Amendments/Additional Information

2016/0189/F
aw

AMENDED
Notes

Listed building and planning consent for conversion of outbuildings to form 2no.holiday cottages at outbuildings Lowdale Hall Sleights

Cross section PROPOSED

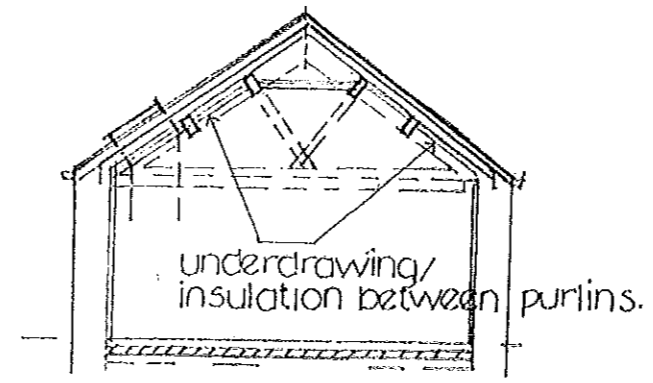
- 1.The window details have been amended as suggested.
2. There appears to be some misunderstanding regarding the ceiling treatment. The section drawing is intended to indicate that underdrawing /insulation will be between the purlins as preferred. I confirm however that this will be the case.
3. The stone flags have been retained for re-use and as suggested my client will agree the details of the re-use with you/your officers on site .
